Memorandum for Mt Welcome, Pukerua Bay, Porirua: FTAA-2603-1181

**Response to Comments on a Substantive Application under section 53 of the Fast-track Approvals Act 2024:
Landscape and Visual Assessment ("Report")**

Memorandum for Mt Welcome, Pukerua Bay, Porirua: FTAA-2603-1181 (“Project”)

Response to a Technical Review Memorandum: Urban Design (“Memo”)

Figure 1: Proposed works within SH59 corridor.

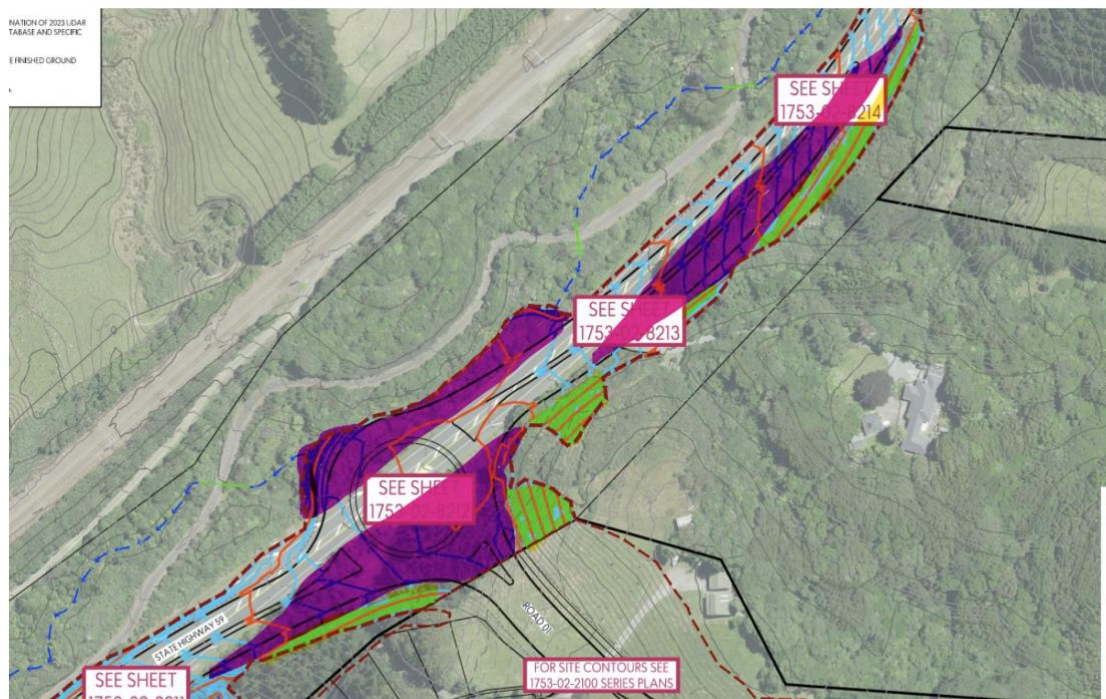
5. The development of a roundabout and road connection into Mt Welcome requires the removal of areas of existing vegetation and cut of batter slopes as set out in Figure 1 below.

6. An extent of the vegetation removal (7,080m²) is proposed with 2,035m² of that area being within Significant Natural Areas 027 and 029. From an ecological perspective, the proposed removal of this vegetation is being addressed through offsetting measures in the ecology report for the Project. The remaining vegetation is a mixture of native and exotic planting with a significant amount being an existing Pine stand with variable under canopy (i.e. fern spp, blackberry and other species).

Figure 2: Plan and section of one of the more prominent cut faces.

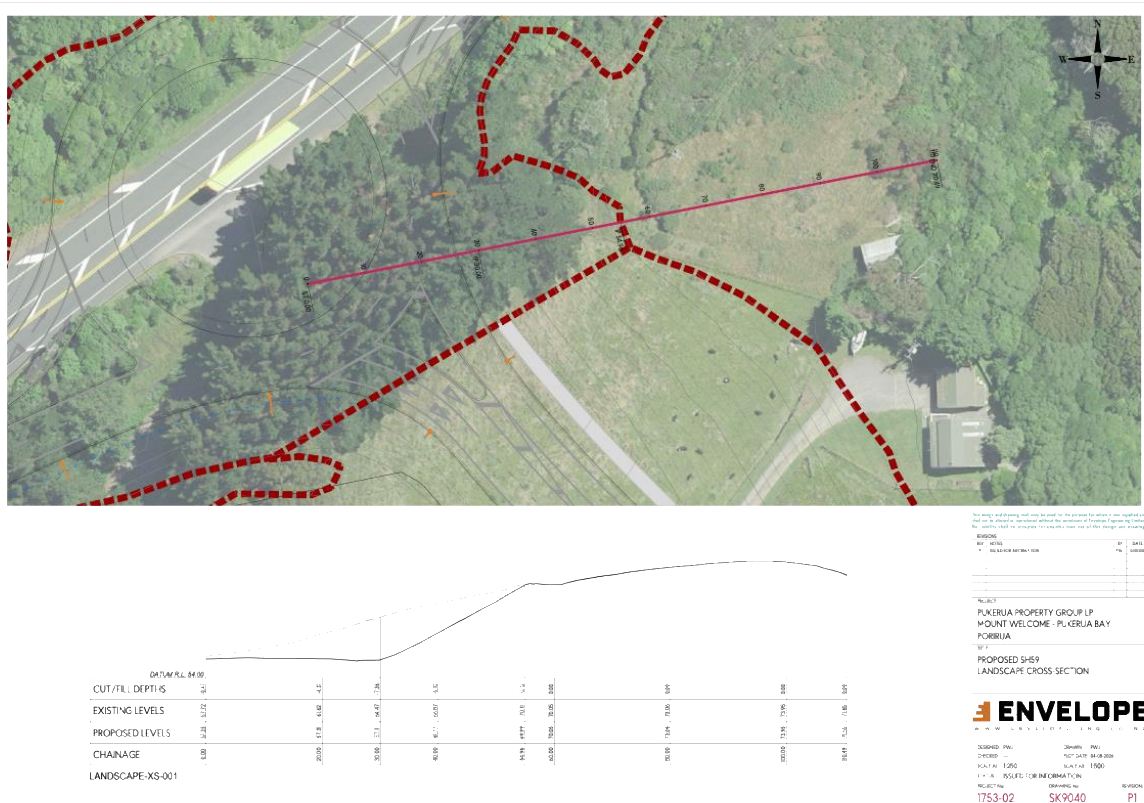
7. Figure 2 above shows a cross section of one of the proposed cuts for the Project which would be visible when travelling north along SH59 and/or turning into the Mt Welcome Development. This cut is 12m tall with a 1:2m slope.
8. There is currently no planting associated with the road corridor shown on the Landscape and Ecological Plans for the Project. The writer assumed that a mitigation planting plan (covering a mix of planting and hydro seeding) would be prepared and submitted to the relevant parties for approval as part of the detailed design phase of the Project. Note proposed condition below to accommodate this.

12. It is considered technically feasible to establish planting on the proposed 1:2 cut slopes using a “plug planting” technique (refer Figure 2 above). However, the health and safety implications, access constraints, and ongoing maintenance requirements are likely to make large-scale implementation impractical. As a result, hydroseeding is expected to be the preferred establishment method across much of the slope.
